STATE OF NORTH CAROLINA
DEPARTMENT OF TRANSPORTATION

Subject: DCM Consistency for the proposed US 70 Havelock Bypass in Craven County. TIP No. R-1015. WBS 34360.1.2.

The North Carolina Department of Transportation (NCDOT) submitted additional information on Havelock Bypass to you on March 13, 2020 for review in regards to the Division of Coastal Management's CAMA Consistency Determination for the project. This package included supplemental information and revised permit drawings. Based on further coordination with the NC Division of Water Resources, further revisions need to be made to this request. This letter is a revised version of the March 13, 2020 request, showing additional and modified information highlighted in red.

**PERMIT DRAWING
SHEET 28 OF 167**

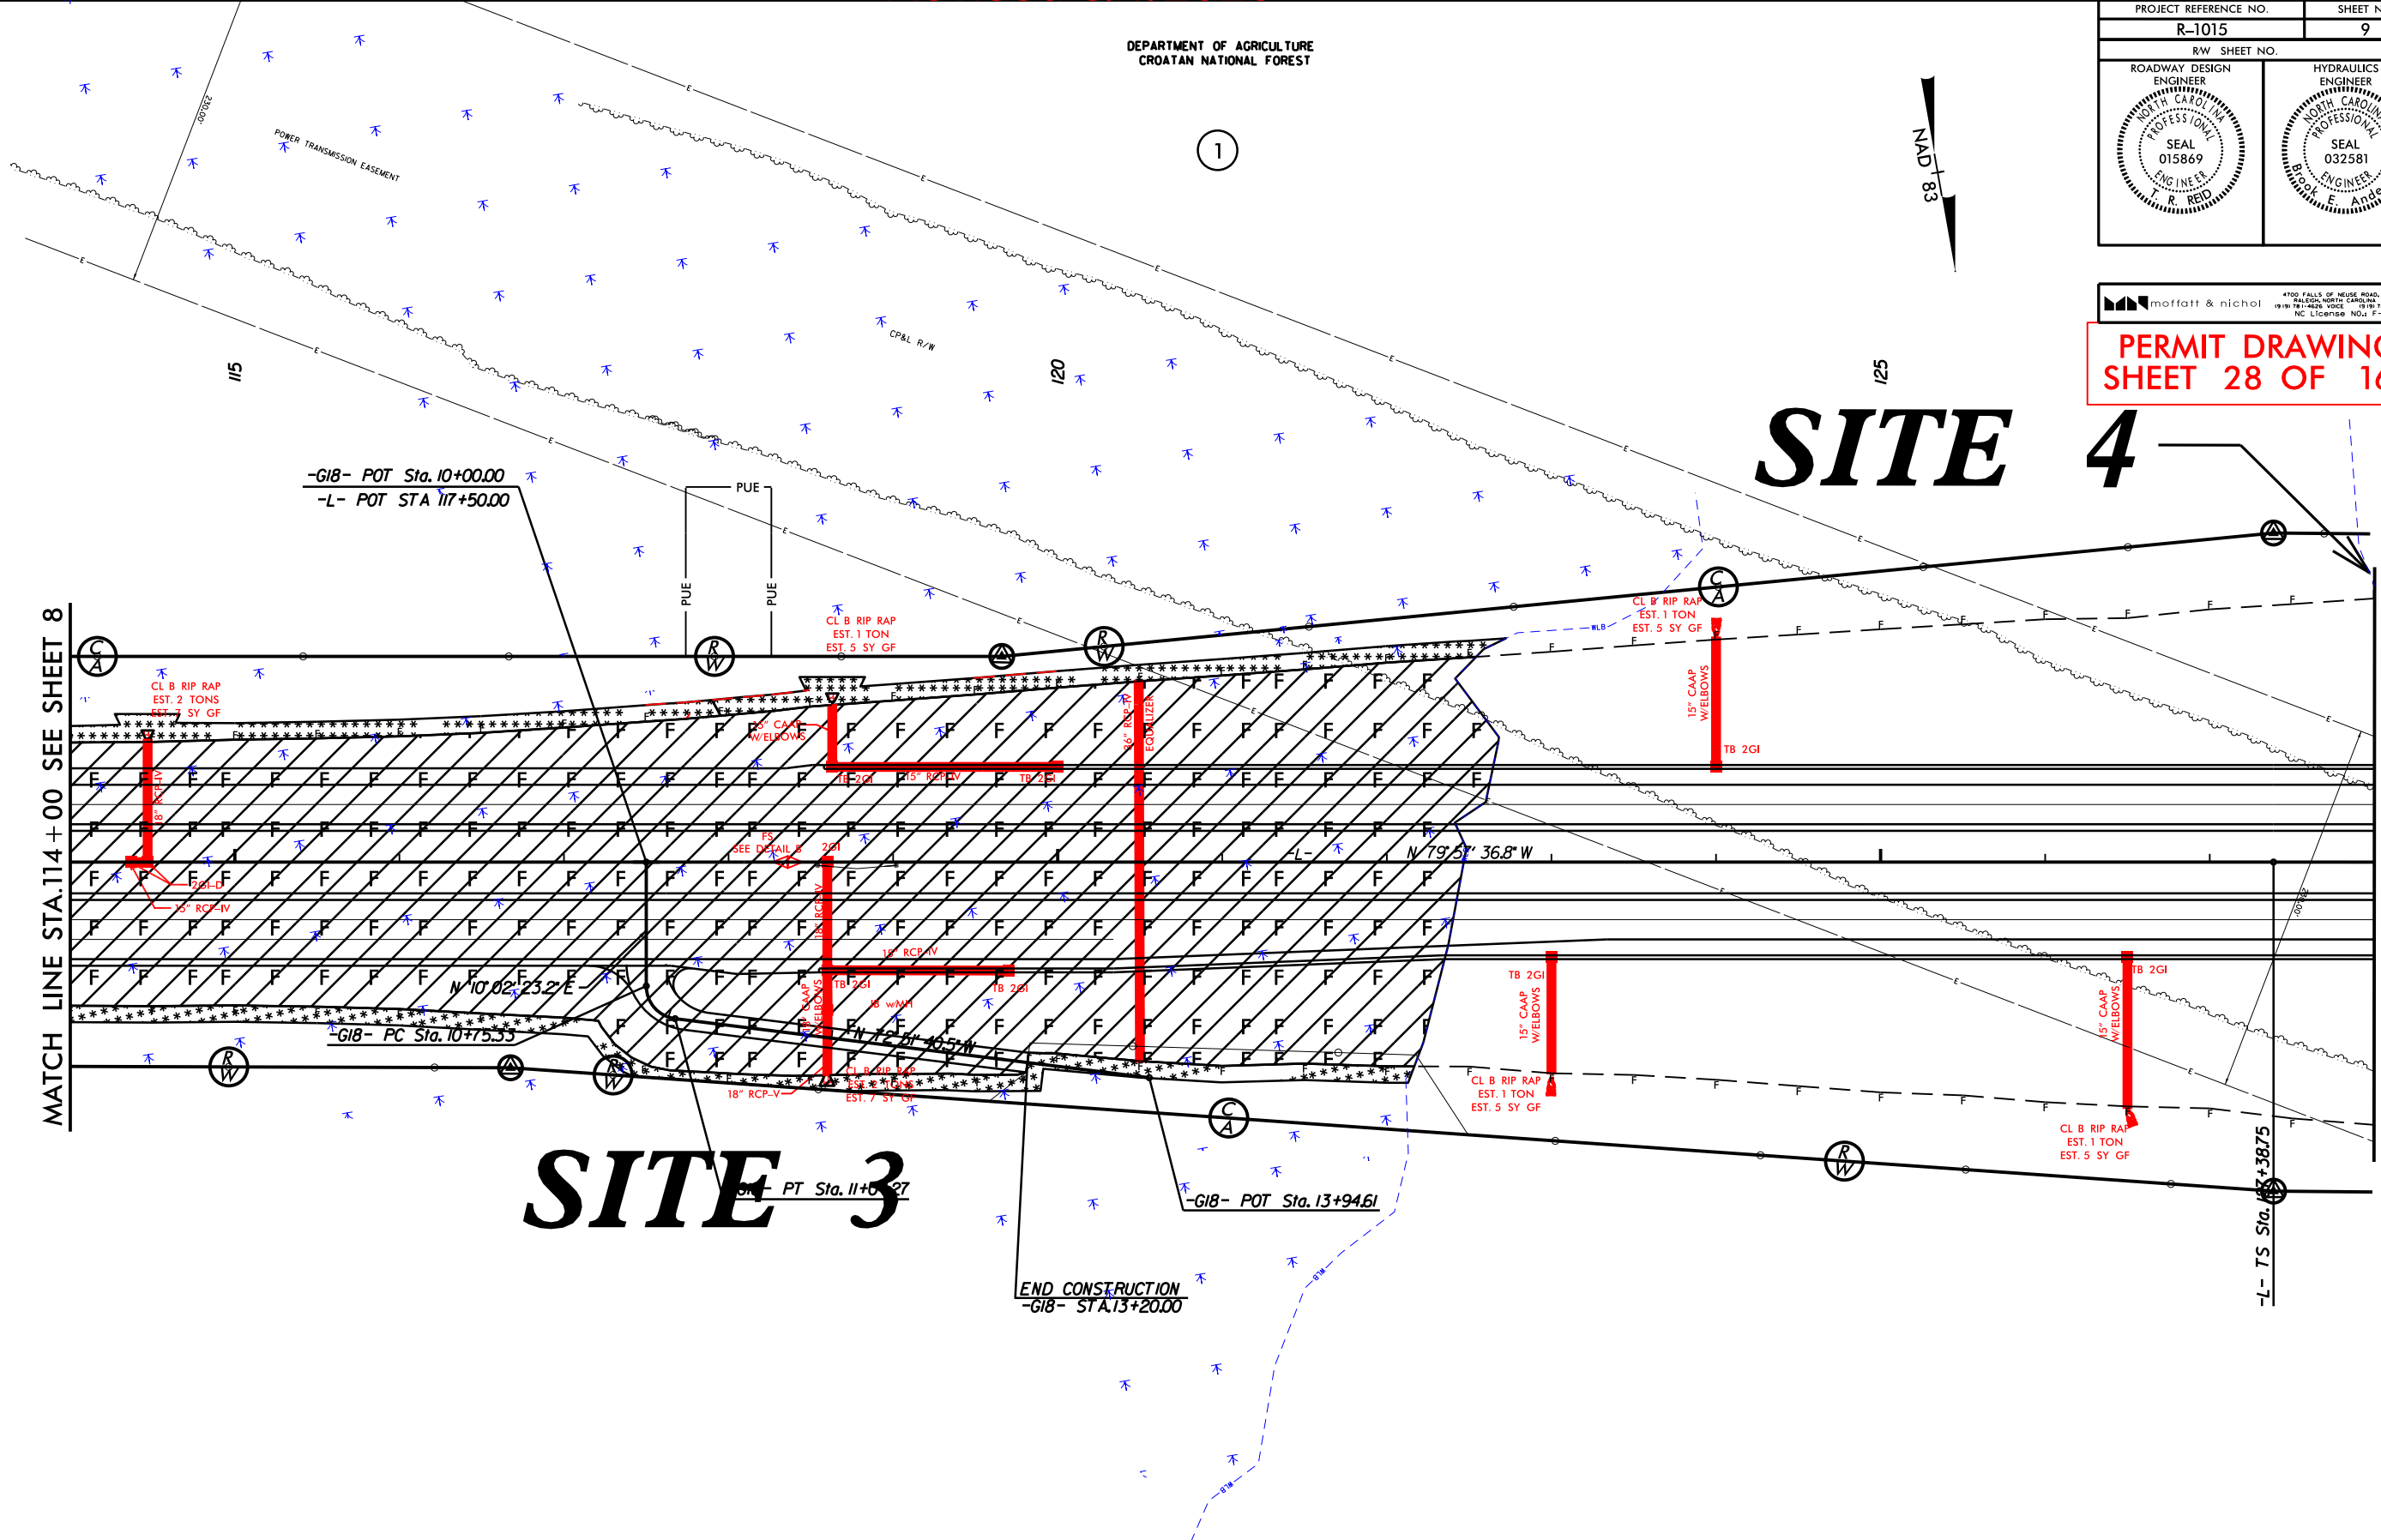
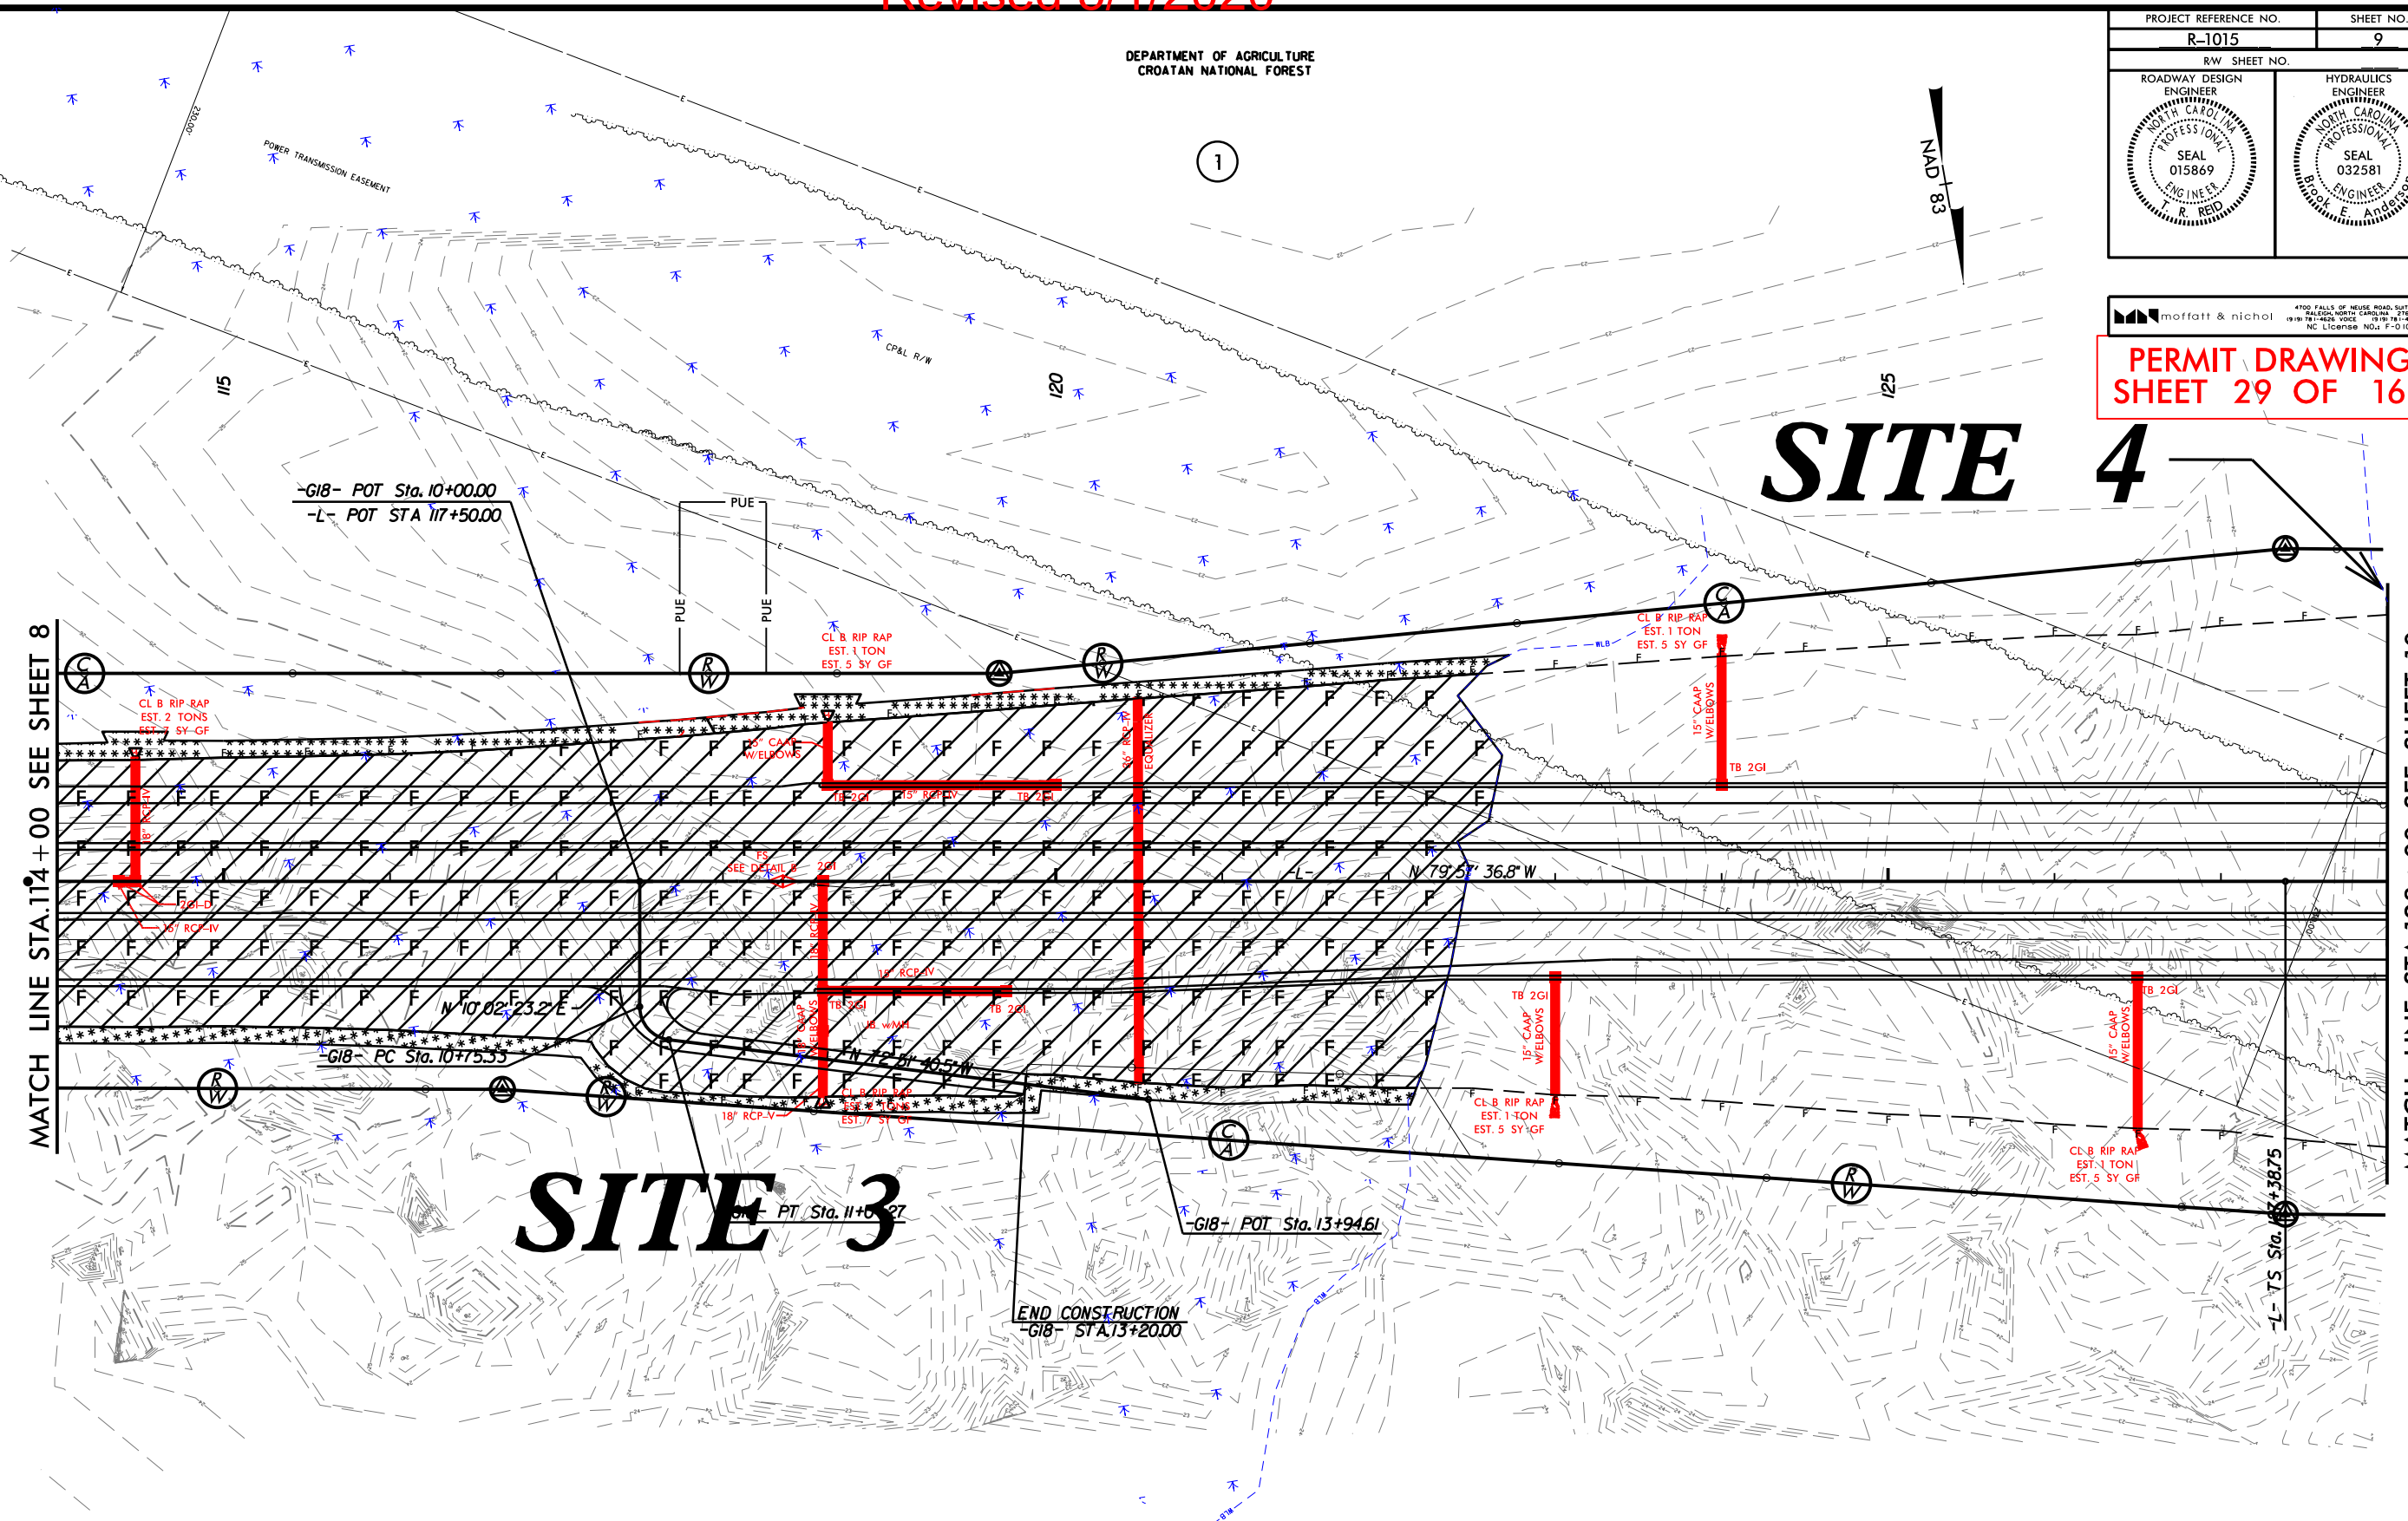
- Site 3: (permit sheets 28 & 29) a driveway was relocated and an error found in the original permit total from 4/9/2019. Fill increases by 0.12 acre. Mechanized Clearing decreased by 0.03 acre. Total difference a 0.09 increase in permanent impacts.

- Actual new Fill Impacts = 26.034 acre, Total old Fill impacts=25.906 acre; actual difference 0.128 acre, rounded difference (26.03-25.91) = 0.12 acre as reported
